**C. AMENDMENTS TO THE DRAWING FIGURES**

This Amendment is in response to a non-final Office Action bearing a mailing date of July 13, 2007.

The Applicant's claimed invention is to a surface-mounted anchoring system for use in the construction of a wall. The wall more specifically is a cavity wall having an inner wythe or, more commonly, a backup wall and an outer wythe or, more commonly, a veneer. In the cavity between the wythes, it is required by some building codes to provide insulation on the exterior of the inner wythe, the integrity of which is to be intact after the anchoring system is installed. All of this information is preamble.

FIG. 2

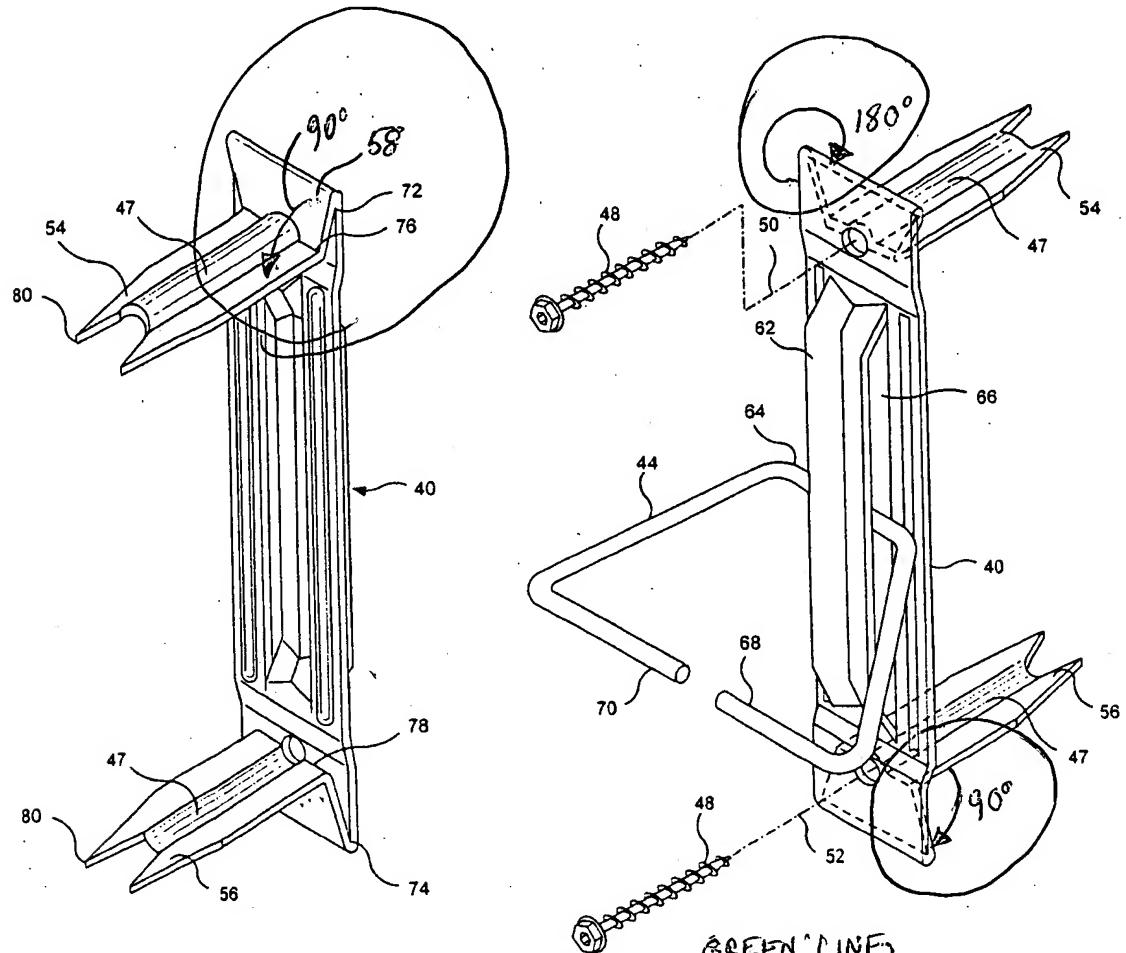
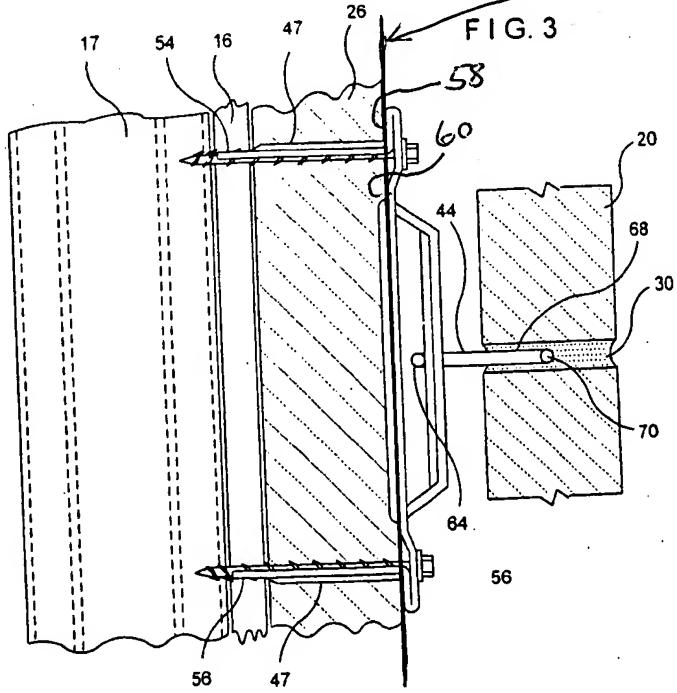
The Examiner errs in Paragraph 3 of the Detailed Action in stating that *the two surfaces are not shown as coplanar in the drawings*. In the visual aid provided herewith a green line is drawn showing the coplanar characteristic of the two surfaces.

The Figures 2, 3, and 4 have been reduced for placement on a single page. The text, when read together with the illustrations, clearly show the sheetmetal bending involved in the construction of this wall anchor. As an aid to understanding the text, colored markings on the drawings provide an additional visual aid. The green angular markings show the leg bends and the red angular markings show the base bends. The green line superimposed on Fig. 4 show surface 58 and surface 60 as being coplanar. A typical series of metalworking steps to produce the finished inboard legs 54 and 56 would include stamping of the basic flat shape, swaging the channels 47, folding the 90° bend between the legs 54 and 56 and the leg bases 58, folding the 180° bend between the leg bases 58 and the base surface 60, and swaging the leg bases 58 and base surface 60 into a substantially coplanar form. The Examiner is requested to re-read the text at Paragraph 62 of the Application

in the light of the above discussion and reconsider Claim 13.
